**TENDER NO: 2024-09**

**Lancaster WWTF Aeration System Renewal**

**LANCASTER WWTF AERATION SYSTEM RENEWAL**

**ADDENDUM NO:** 3

**DRAWING TITLE**  
TYPICAL CONSTRUCTION DETAILS - AERATION SYSTEM

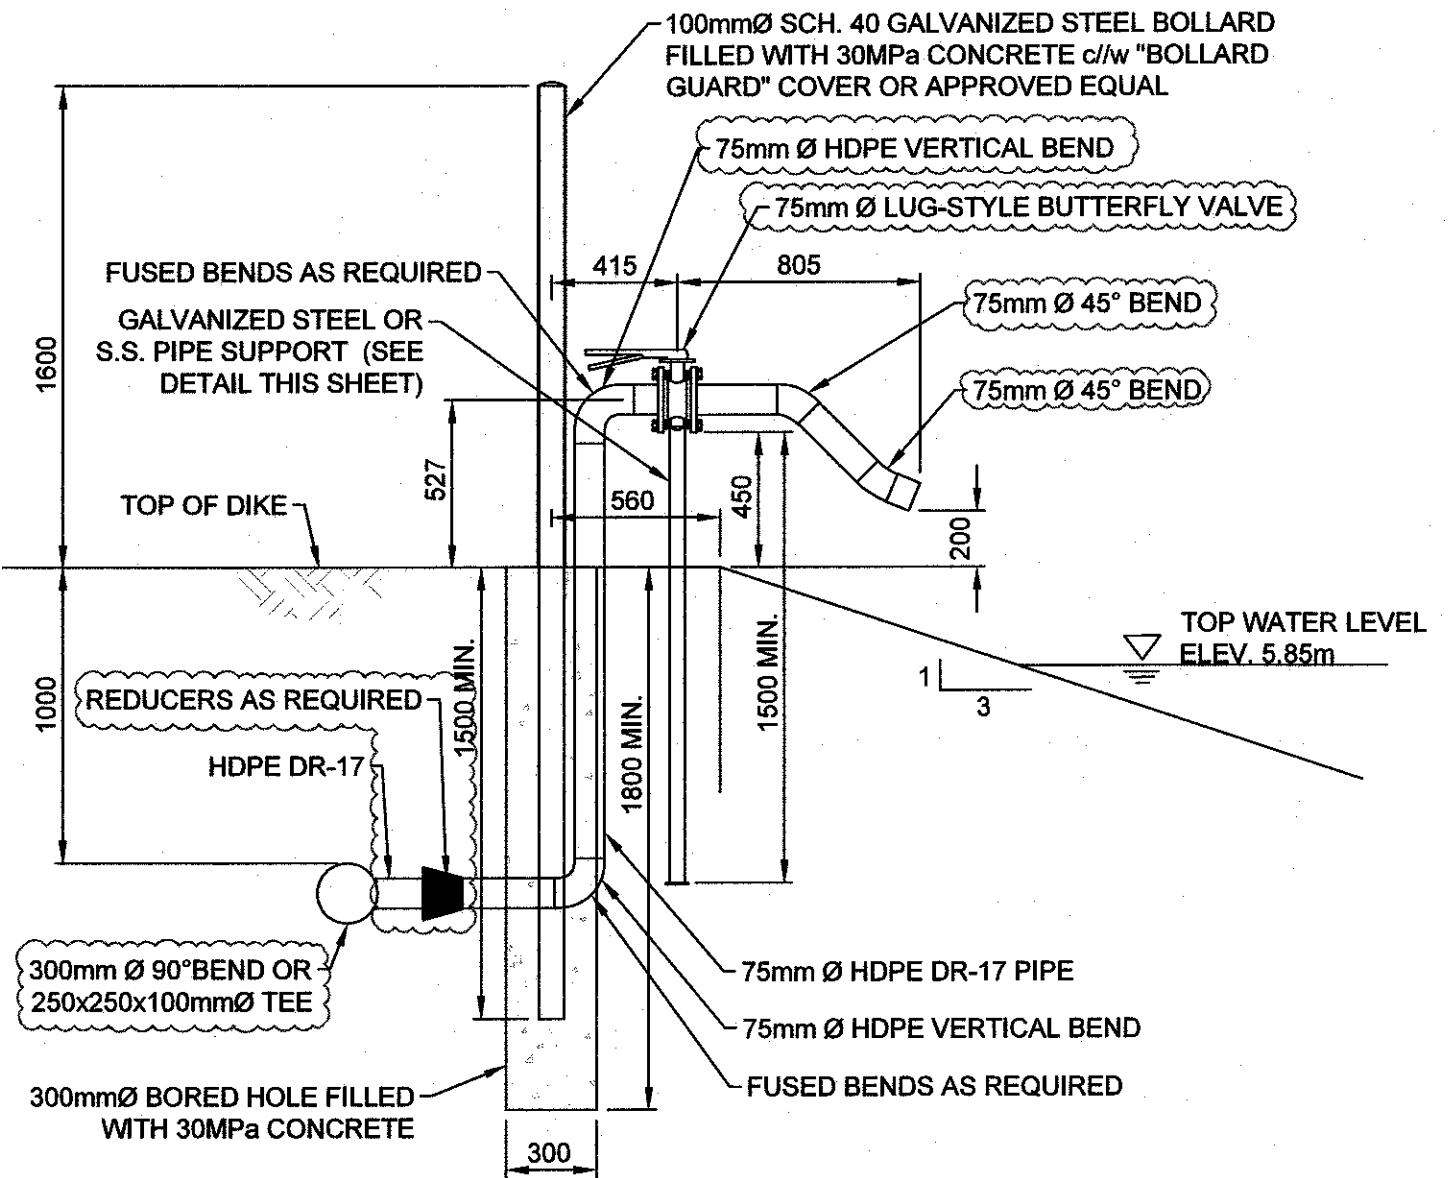
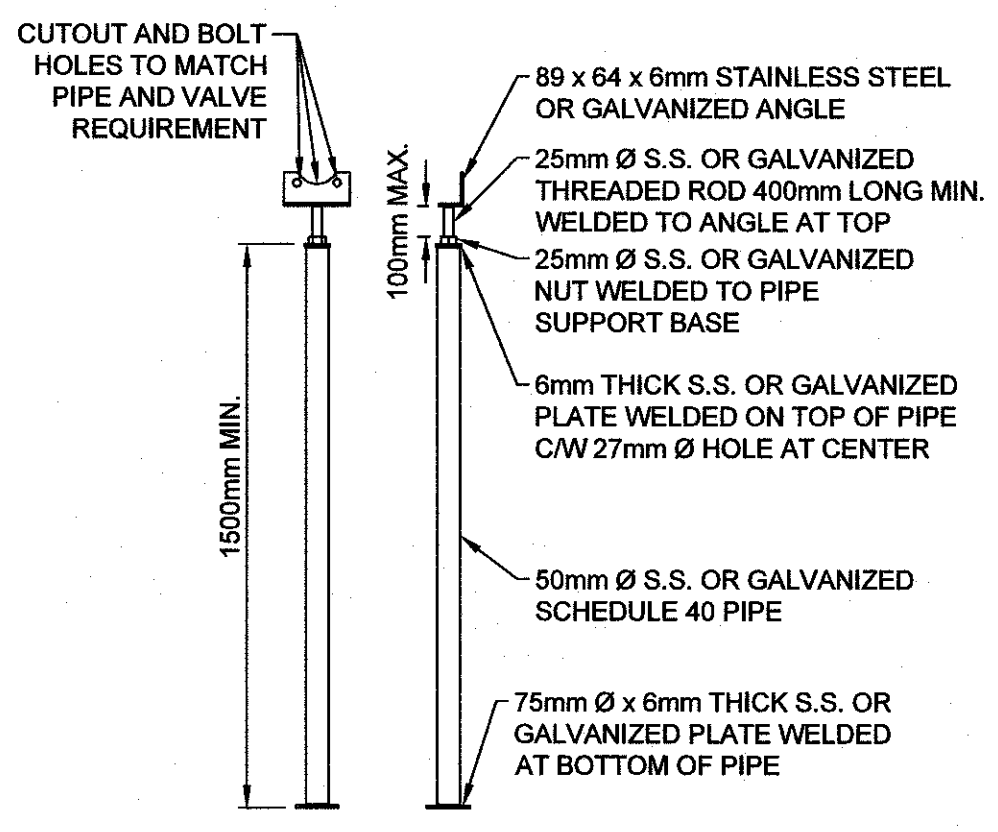
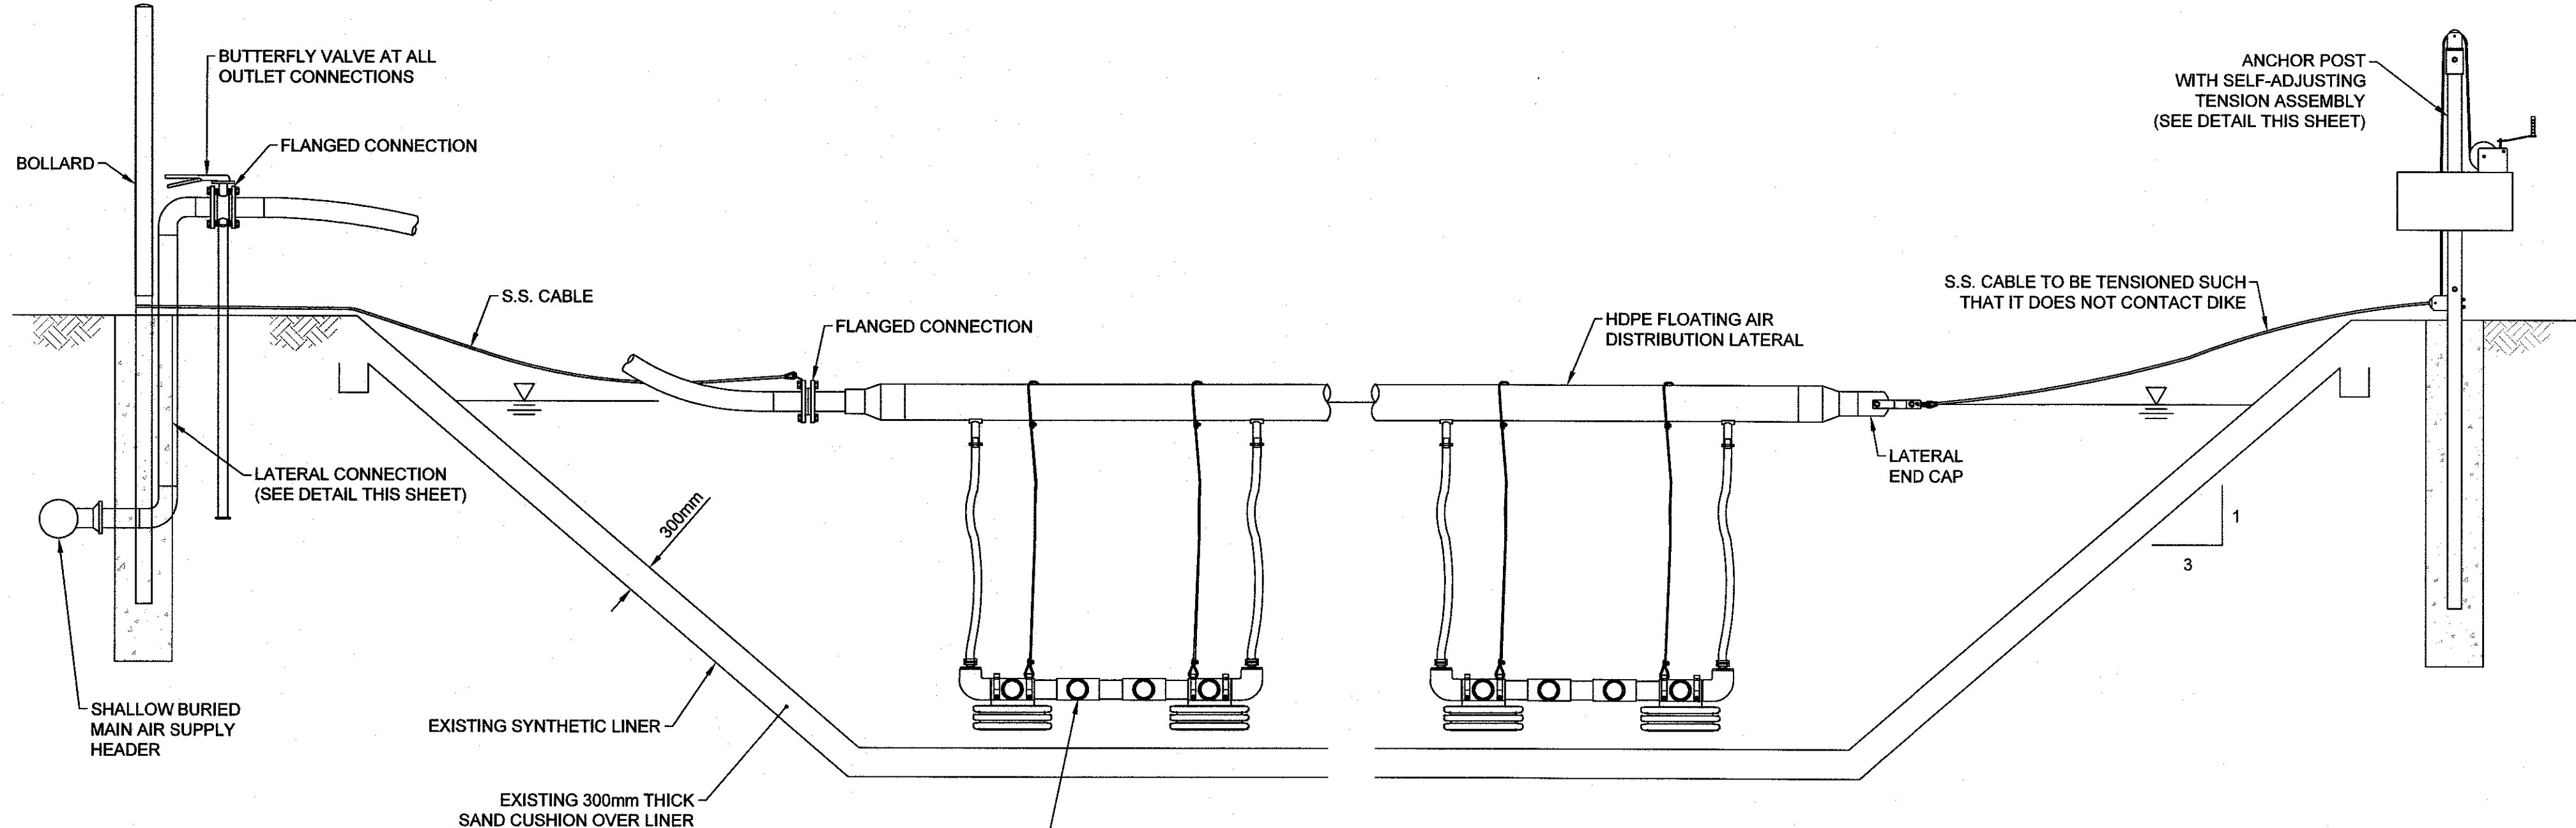
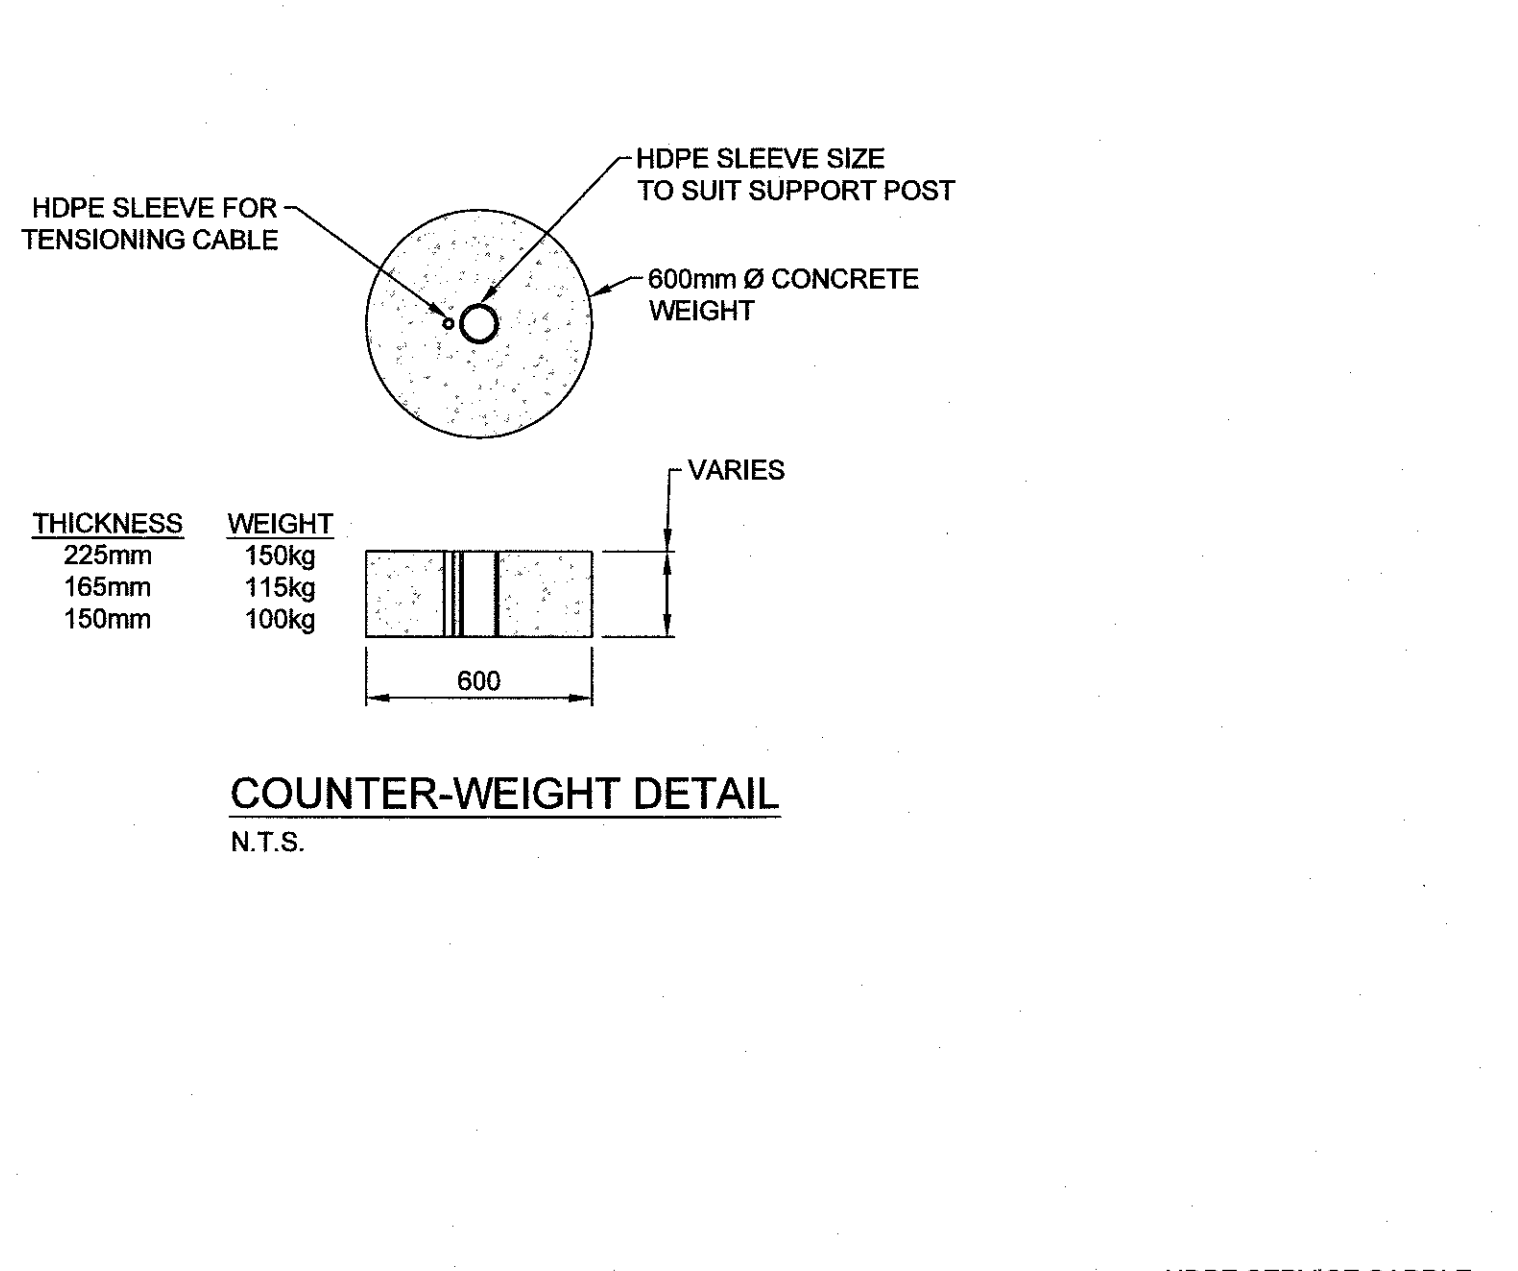
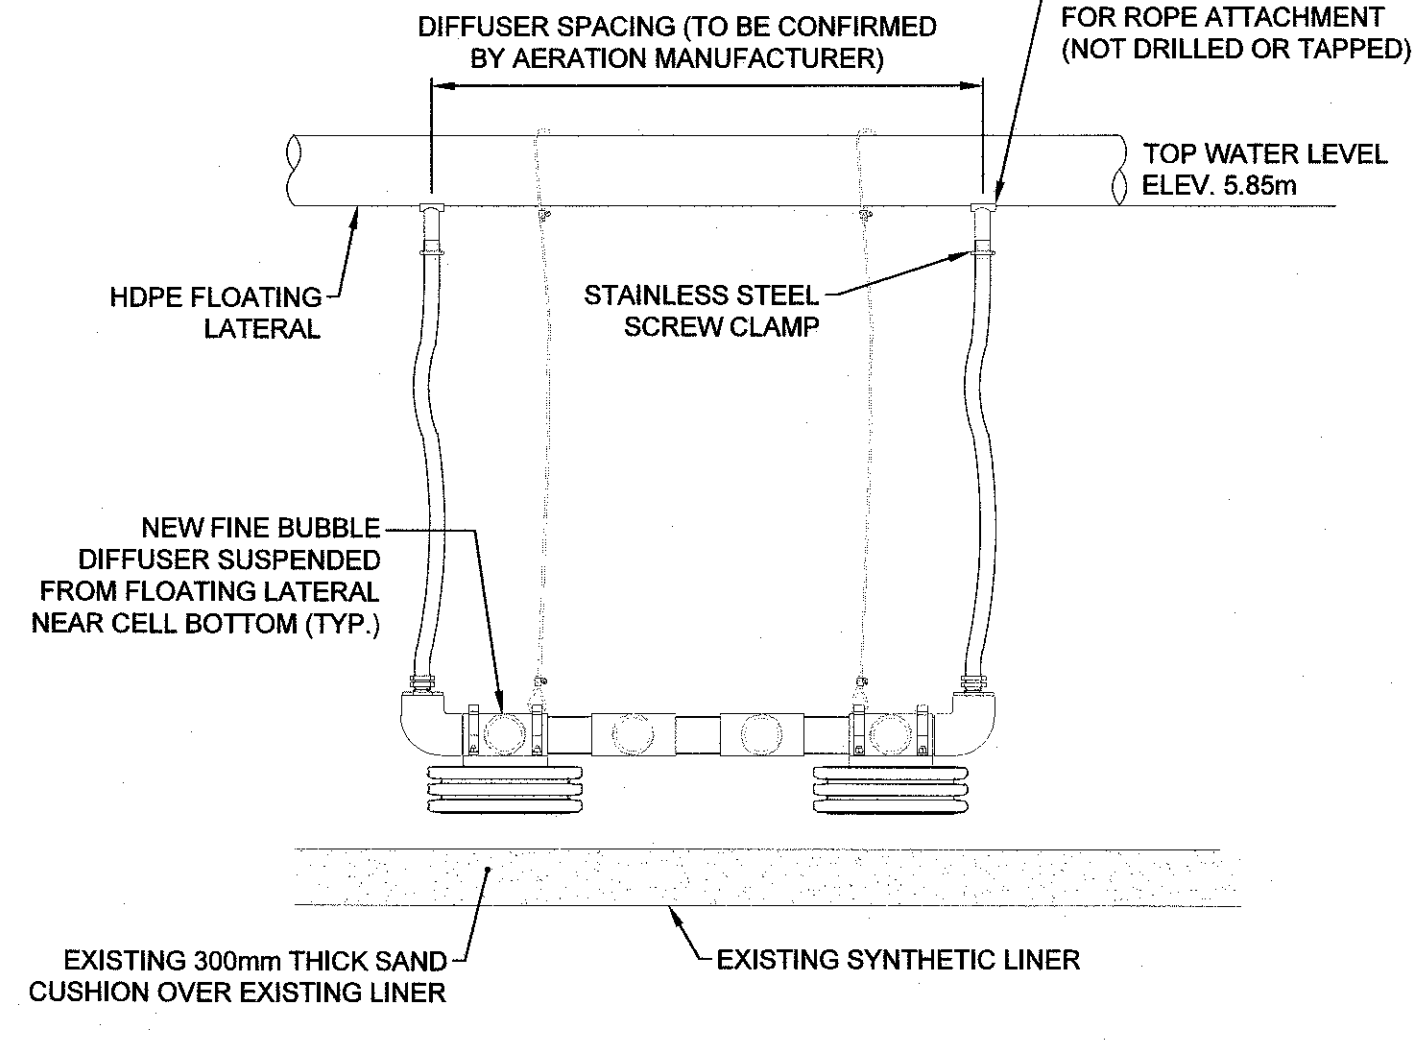
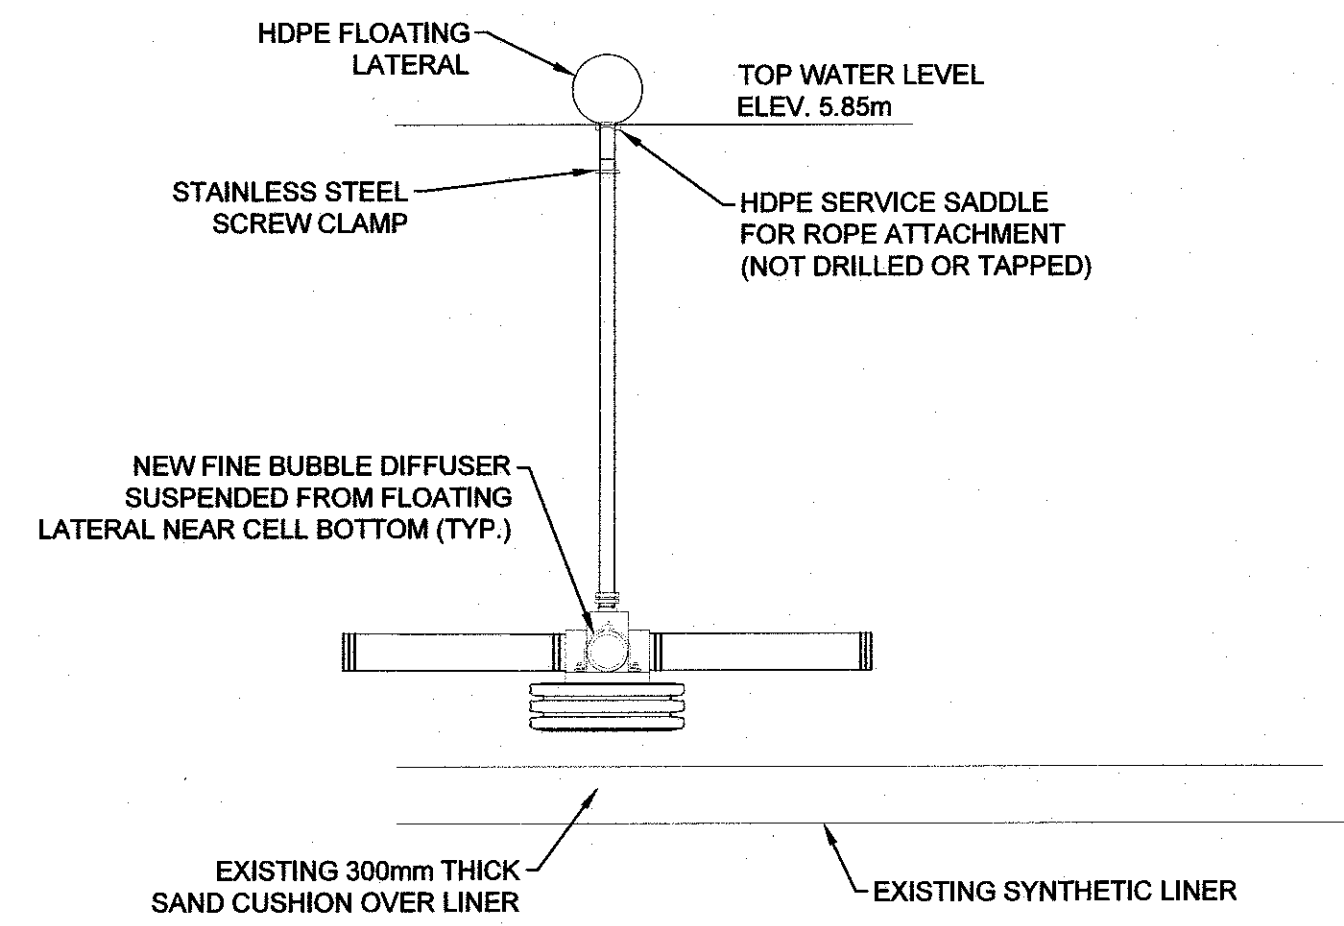
**Q2:** Section 10 81 01, Item 2.5.2 (Page 106) states the aeration system supplier must confirm header sizing as part of the overall design responsibility. The header is being provided by others; the aeration system supplier has reviewed the header sizing and agrees with the 300mm header from the building to cell #1, but recommends the header to cells #2, 3, 4 be increased to 300mm and reduced to 250mm after the sixth lateral in cell #2, instead of the 200mm indicated on the drawing set.

**A2:** Please see attached updated Sheet 8 of 14 and 9 of 14 of the drawing set.
